**Advanced Passive 1000 (AP1000)
Generic Technical Specification Traveler (GTST)**

Title: Changes Related to LCO 3.7.12, Spent Fuel Pool Storage

3.7.12 Spent Fuel Pool Storage

Figure 3.7.12-1
Minimum Fuel Assembly Burnup Versus Initial Enrichment for Region 2 Spent Fuel Cells

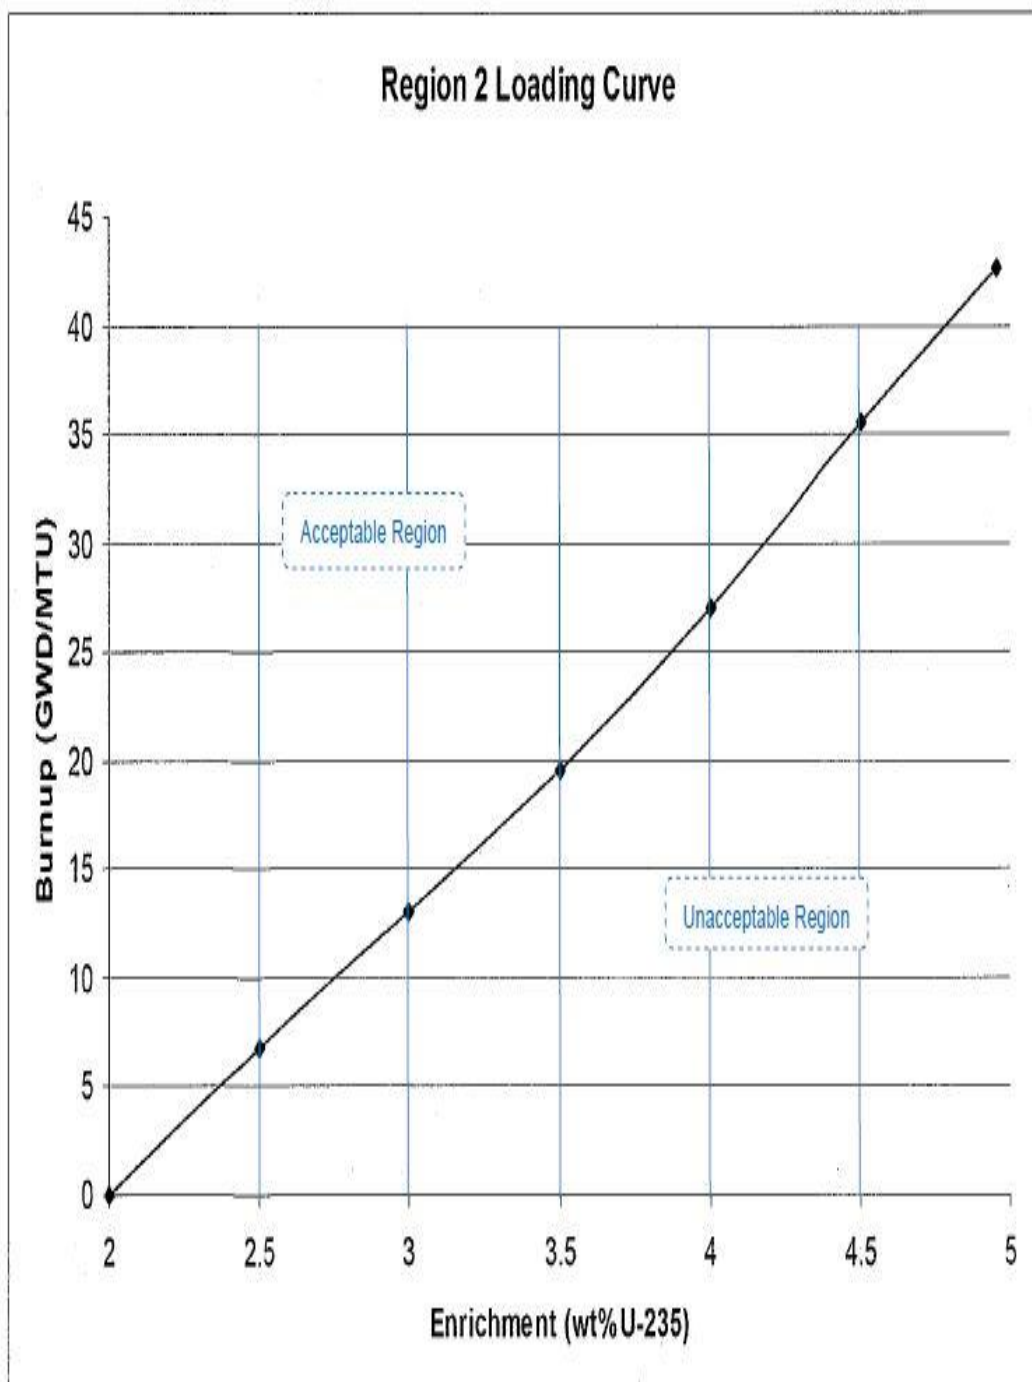
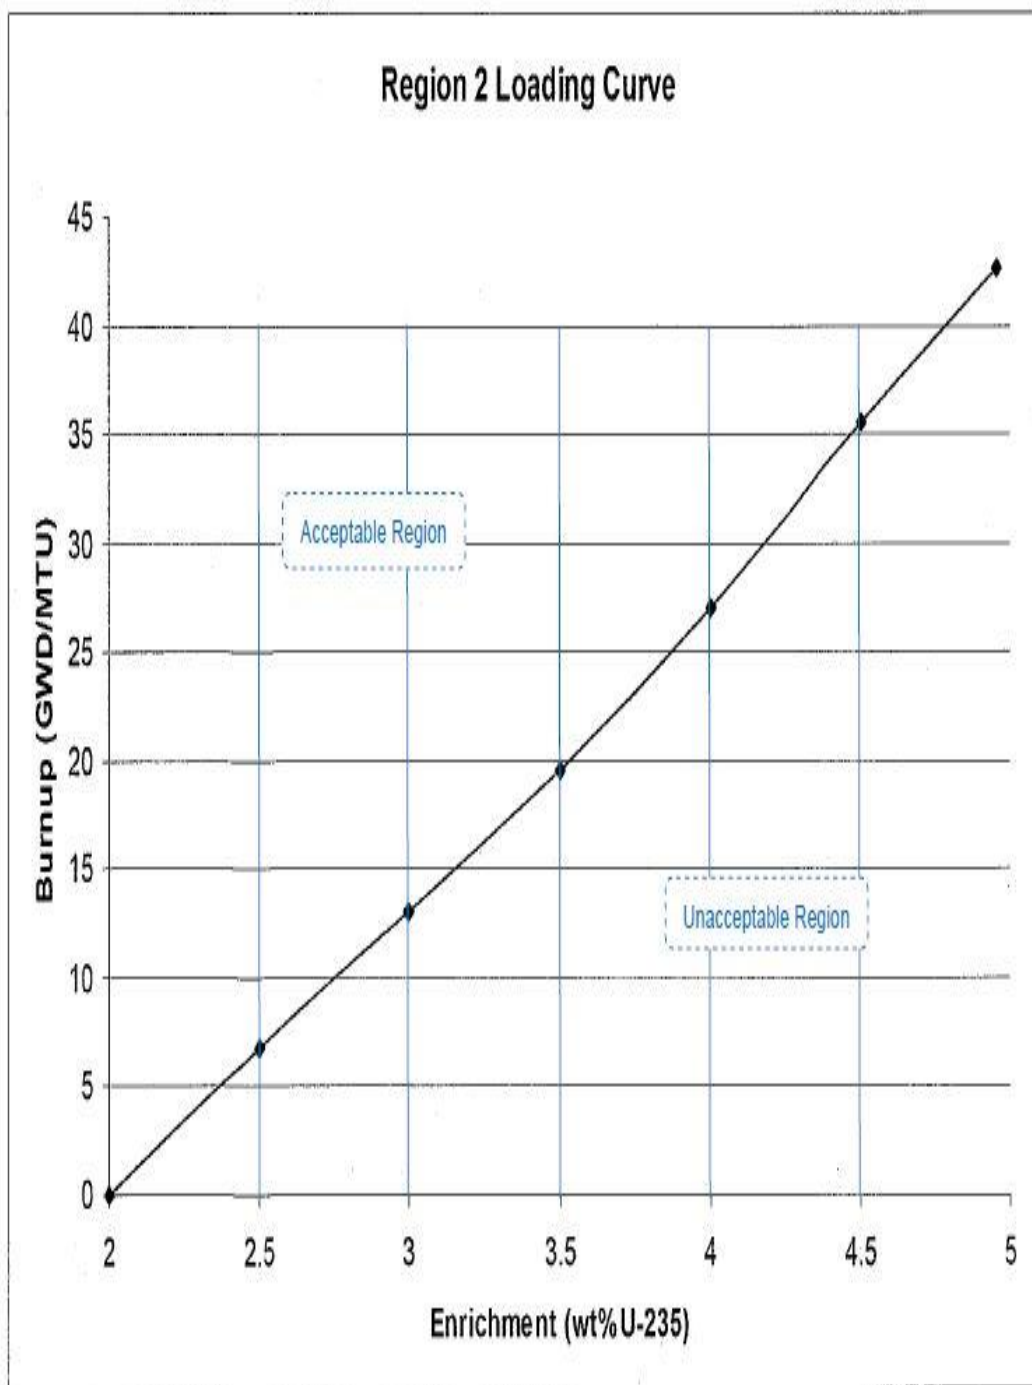
VEGP LAR DOC A111: Revision of Figure 3.7.12-1

GTS Figure 3.7.12-1 is revised by adding area labels to provide clarity. (DOC A111)

VEGP LAR DOC A111 annotates the acceptable and unacceptable regions for loading on Table 3.7.12-1.

Region 2 permits storage of spent fuel assemblies in any cell location provided the assembly meets the combination of initial enrichment and burnup shown in LCO Figure 3.7.12-1, Minimum Fuel Assembly Burnup Versus Initial Enrichment for Region 2 Spent Fuel Cells. **The Acceptable Region of the Figure is to the left and above the curve.**
